Conclusion of the Power-to-Gas Stream of Work

Hydrogen Europe

Alkaline Water Electrolysis OEM position on DCC 2.0 regulation

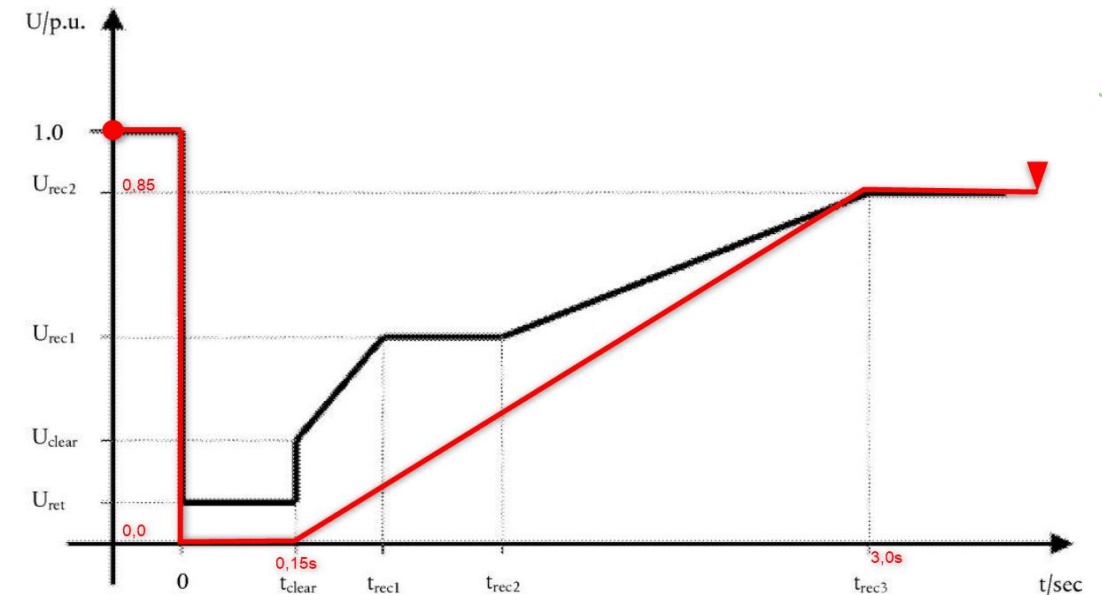
- c. When the network voltage resumes, after the fault has been cleared, to ~~a value within the voltage range of 0,85 pu – 1,1 pu~~, a value within the voltage range specified in Art. XX.1(b) for unlimited time of operation, a power-to-gas demand unit shall recover its active power consumption level at the connection point ~~The relevant TSO shall specify the magnitude and time for active power recovery~~ according to the specification provided by the relevant TSO. The relevant TSO shall define:
- (i) A magnitude and accuracy within the range from 80% to 100% of the pre-disturbance active power consumption level.
 - (ii) A recovery time in the range from 1 seconds to 5 seconds, except for the synchronous area Ireland and Northern Ireland where the range shall be 0,5 seconds to 5 seconds.

- ☐ Ireland is outside of the core market of OEMs with current FRT ranges
- ☐ Update of the FRT profile for P2G

Inclusion of magnitude, accuracy and time for active power consumption recovery after low voltage FRT events and consideration for voltage-dependent loads.

✓ Good compromise as it provides clear boundaries for product development

LFSM case study | LFSM recovery could mean around 690 MW of additional demand in just 1.2 seconds for a European example plant

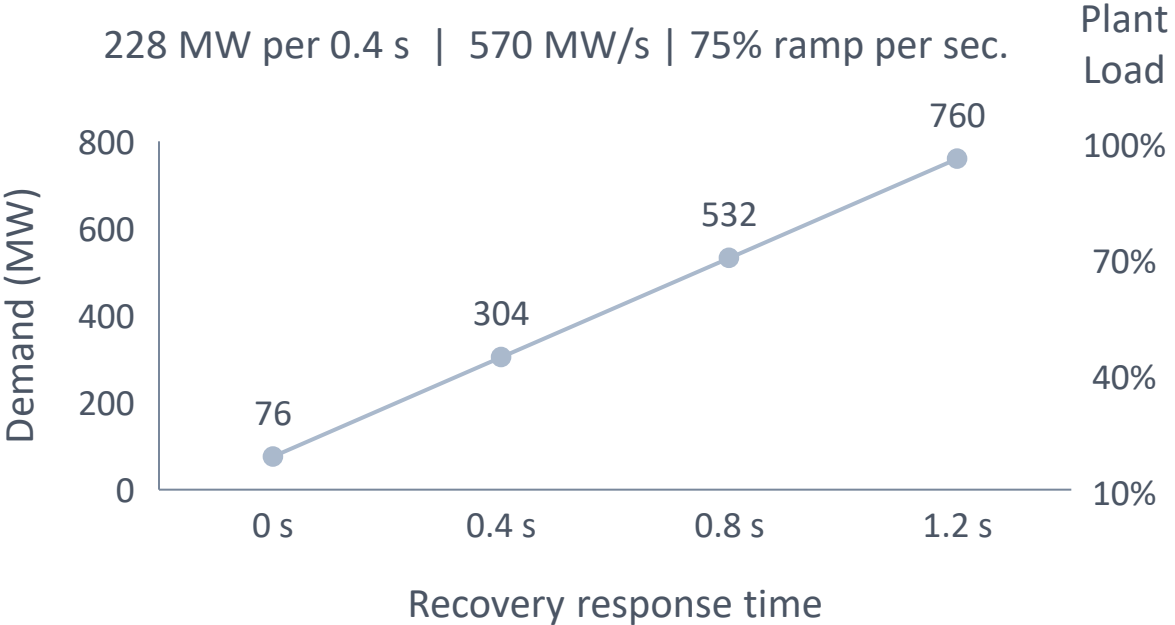
- Frequency drops to 49.x Hz
- Demand reduction from 100% to 10% in 1.2s (76 MW) to support the grid via LFSM-U
- Subsequent ramp-up to initial load-point at 100% (760 MW)

Recovery after frequency stabilises at 50 Hz

+684 MW in 1.2 s
